SUBJECT: COMANCHE PEAK STEAM ELECTRIC STATION
DOCKET NOS. 50-445 AND 50-446
SUBMITTAL OF PROPOSED UNIT 1
TECHNICAL SPECIFICATIONS

**Technical Specifications
for**

CCMANCHE PEAK S.E.S.

INITIAL SUBMITTAL

Figure 3.1-1

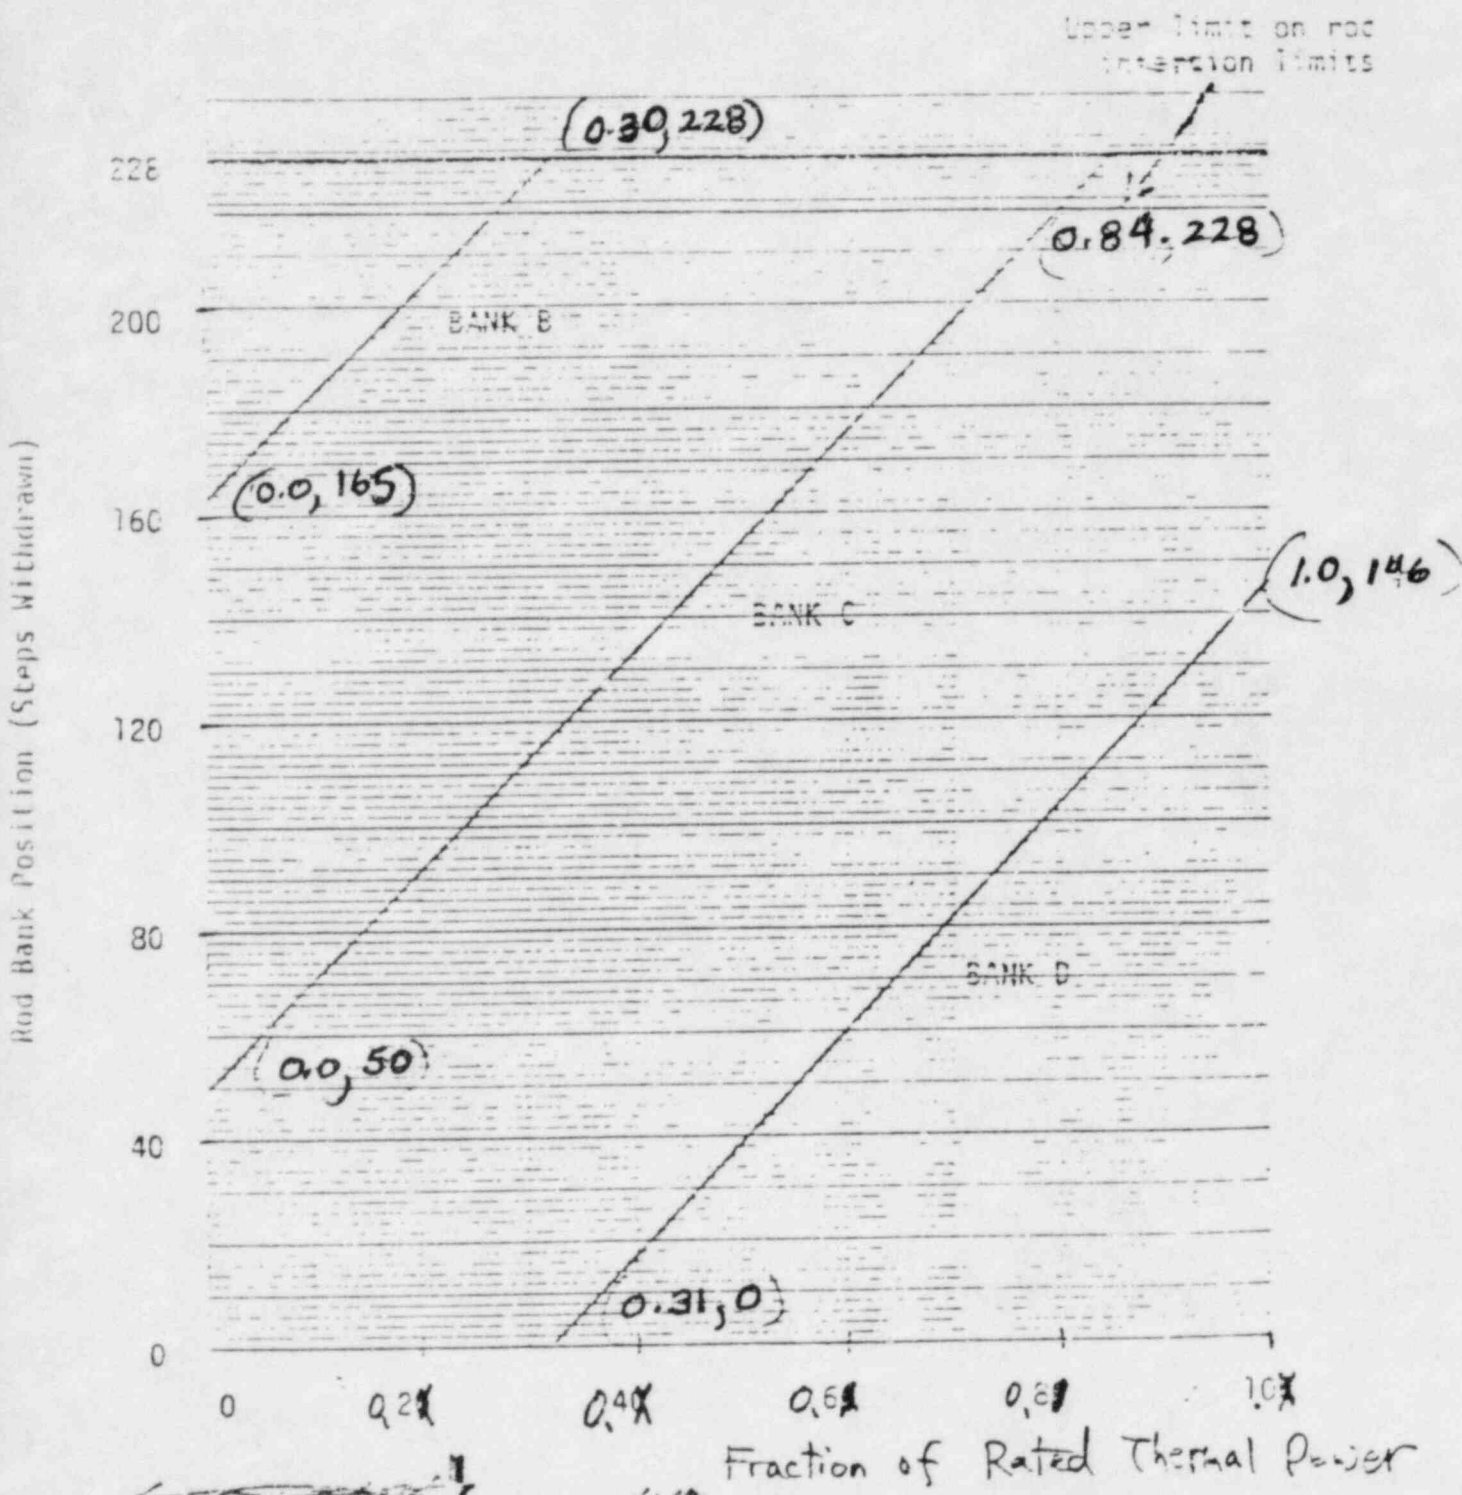
3.1.3.6 The control banks shall be limited in physical insertion as shown in Figure ~~(3.1-1) and (3.1-2)~~.

Rod Group ~~Insertion Limits~~ Insertion Limits
 VERSUS Thermal ~~Power~~ Power
 Four - ~~Operational~~

Figure 3.4-4

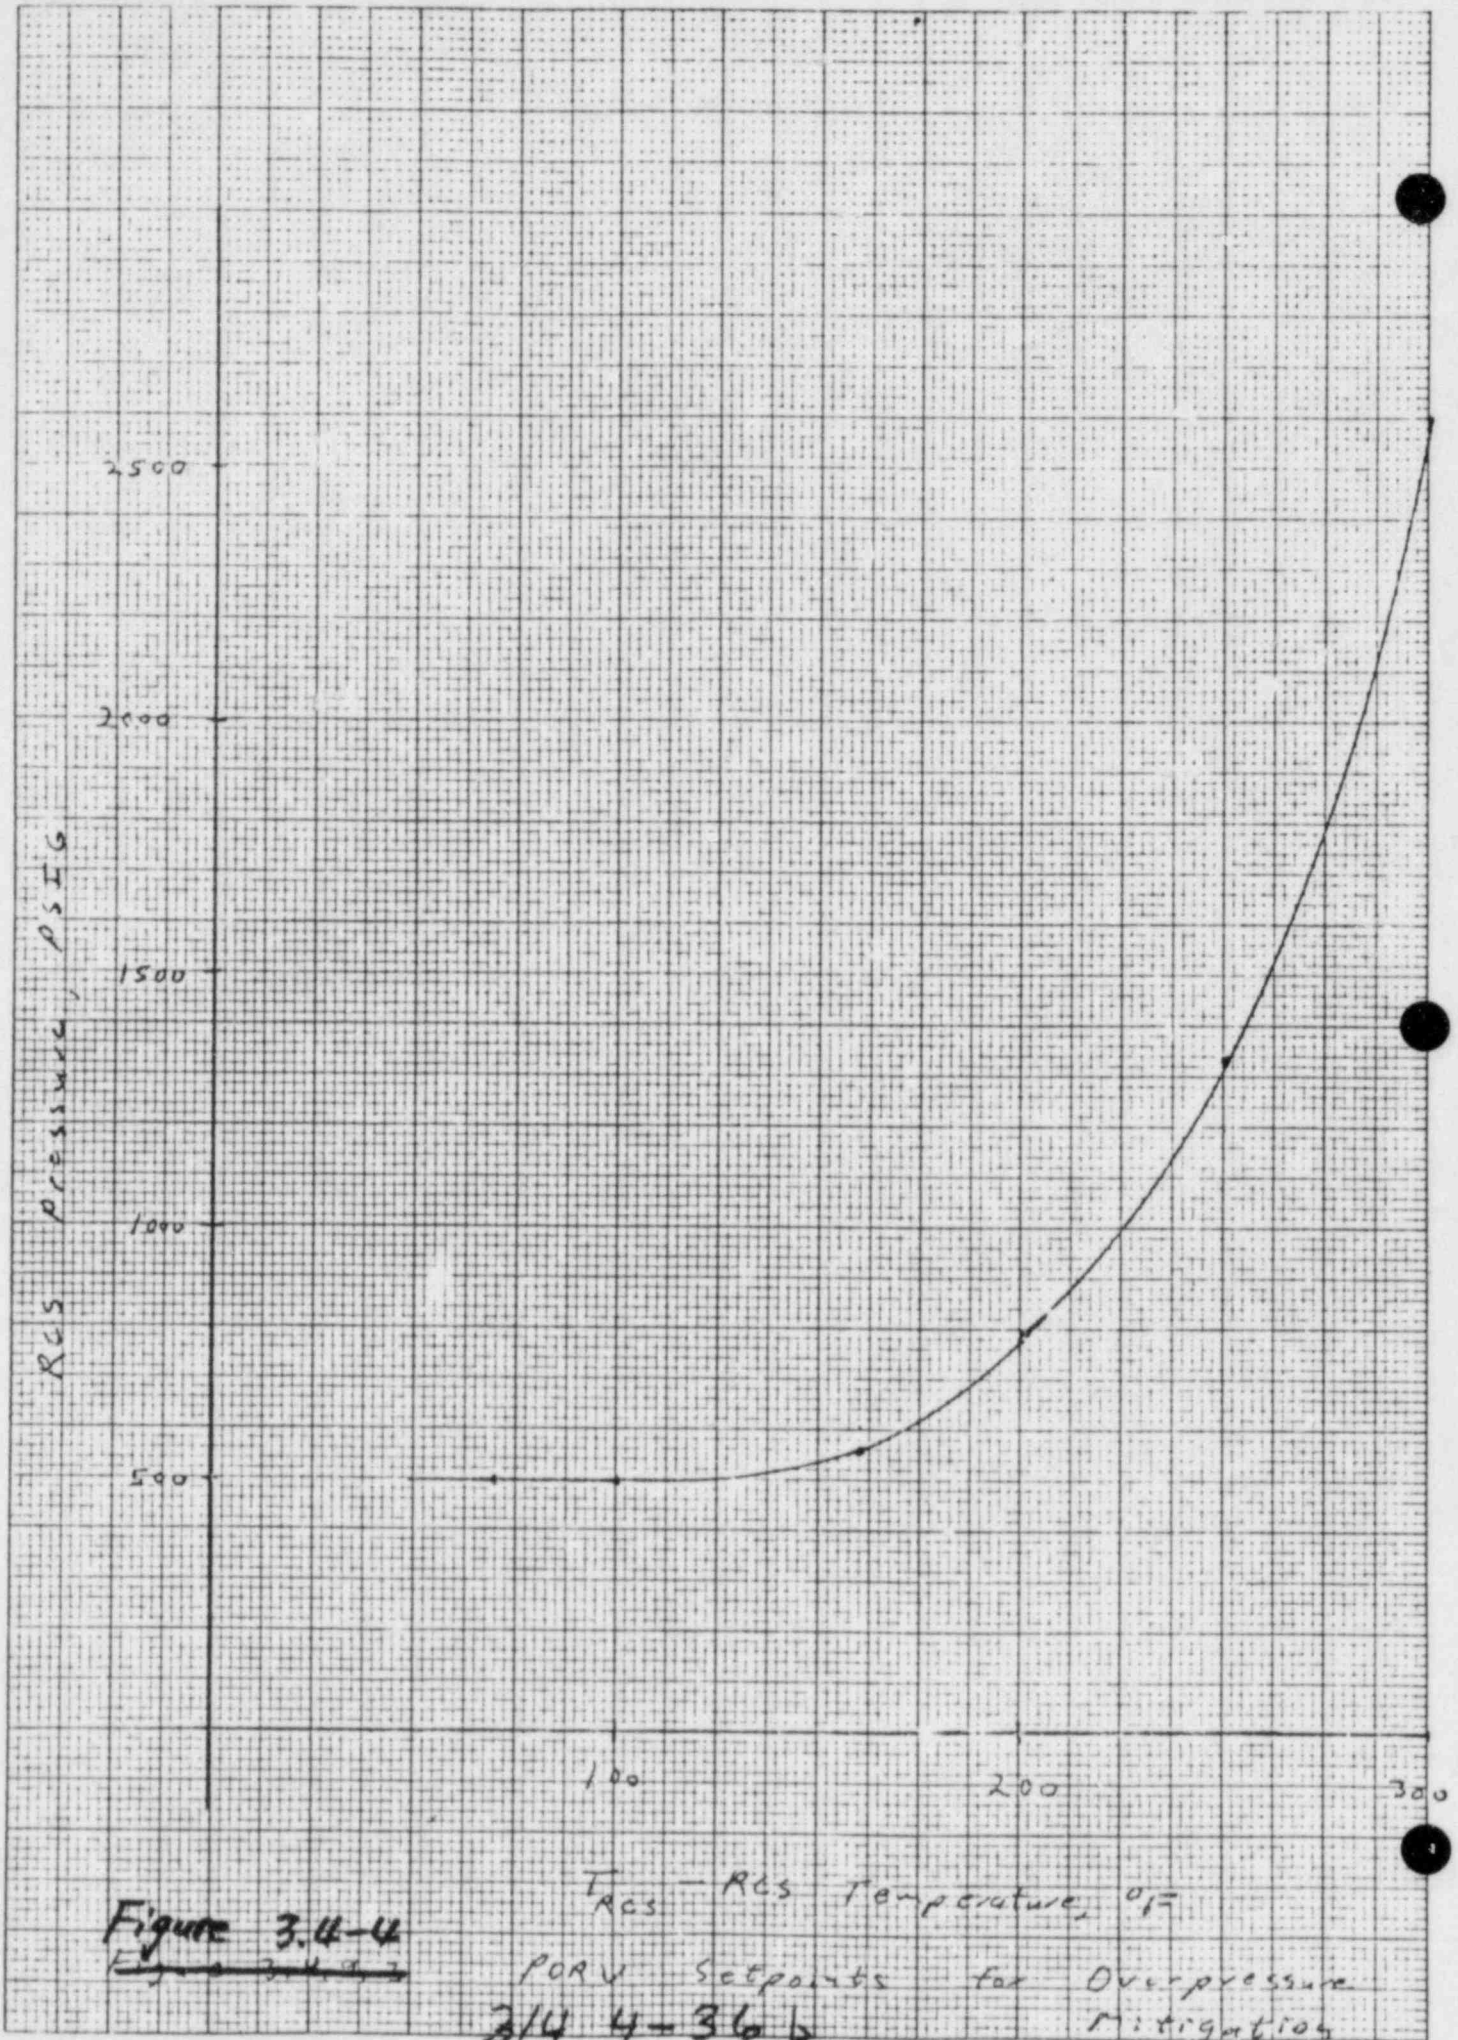
- a. Two power operated relief valves (PORVs) with ~~a lift setting of less than or equal to (450) psig~~ ^{maximum setpoints} or which vary with RCS temperature as shown on Figure 3.4-4 (selected setpoints are listed in Table 3.4-3).
- b. The Reactor Coolant System (RCS) depressurized with an RCS vent of greater than or equal to () square inches.

* These setpoints are the maximum value versus temperature that will mitigate a ~~the~~ pressure transient ~~to~~ ~~for~~ ~~plant~~ ~~condition~~ to below the Appendix G limits for ^{plant operating} conditions as described in the Technical Specifications.
